MONTGOMERY COUNTY HISTORIC PRESERVATION COMMISSION STAFF REPORT

Address: 10001 Menlo Ave., Silver Spring Meeting Date: 10/13/2021

Case No.: 966990 Staff: Dan Bruechert

PROPOSAL: Fence Installation

Figure 2: The highlighted fence is a 4' picket, and red 'x' at the rear are a 6' solid board fence.

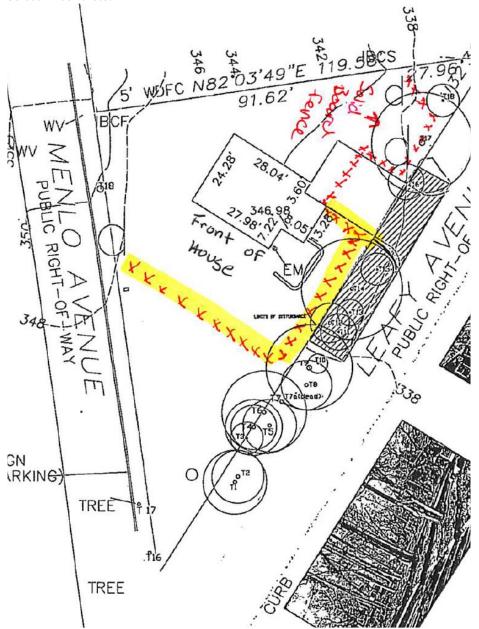
The applicant proposes to install two types of wood fences at the subject property. At the front of the house, which faces the intersection of Menlo and Leafy Aves., the applicant proposes to install 276' (two hundred seventy-six linear feet) of 4' (four-foot-tall) gothic picket fence. The pickets will be 1" × 4" × 4"

(one inch, by four inches, by four feet tall). At the rear of the property, along Leafy Ave., the applicant proposes to install 77' (seventy-seven linear feet) of 6' (six-foot-tall) solid board fence. The posts will all be set in concrete.

Staff finds that the lower picket fence is consistent with the HPC's typical requirement that fences in front of the historic rear wall plane be lower than 48" (forty-eight inches) and have an open picket character to preserve the character of the streetscape and recommends approval under 24A-8(b)(1).

Because of the unique triangular shape of the subject property, the taller solid board fence requires further examination. As stated above, the reason for the lower, open picket design is to preserve the open character of the streetscape. This allows most interior lots on traditional blocks to install taller, solid fences at the rear to create additional privacy without impacting the district's character. Staff finds that the solid board fence will not disrupt the open character of the surrounding district. It is important to note that no houses front the west side of Leafy Ave. The houses to the north of the subject property front

Menlo Ave. and run the entire width of the block, with access from the rear at Leafy Ave. This significantly changes the character and settlement pattern of this block, so the west side of Leafy lacks the formal setback found elsewhere in the district. Staff finds that photographs of this block do not effectively demonstrate the character of the district and recommend the Commissioners conduct a site visit or utilize Google Street View for a more thorough understanding of the character of this section of the district.¹

Staff notes that DPS will be the final arbiter for determining if the Leafy Ave. side of the property is also considered the 'front' for zoning purposes. If that side of the property is determined to be the front, other limitations on the fence height and placement may be required.

Staff recommends that the Commission <u>approve</u> the HAWP application under the Criteria for Issuance in Chapter 24A-8(b)(1) and (d), having found that the proposal will not substantially alter the exterior features of the historic resource and is compatible in character with the district and the purposes of Chapter 24A;
